BC BUILDING CODE INTERPRETATION COMMITTEE

File No: 18-0141

INTERPRETATION

Interpretation Date:	September 21, 2021
Building Code Edition:	BC Building Code 2018
Subject:	Egress from 3 storey townhouse
Keywords:	Egress, townhouse, suite over another, balcony, travel distance limit to exit exceeding 1 storey
Building Code Reference(s):	9.9.9.1 (2) & (3)

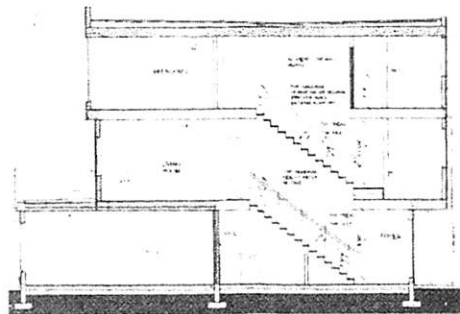
A 40m² CRU is located at the first storey of a 3 storey townhouse as shown in the cross section below. Exiting from the dwelling unit is at the first storey with no balcony on the third storey. Can the third storey be provided with an openable window for egress purposes in accordance with Sentence 9.9.9.1.(2)?

No.

Sentence 9.9.9.1.(2) is not applicable because the CRU is a separate suite.

The egress can be provided in accordance with Sentence 9.9.9.1.(3) which requires direct access to a balcony on the third storey.
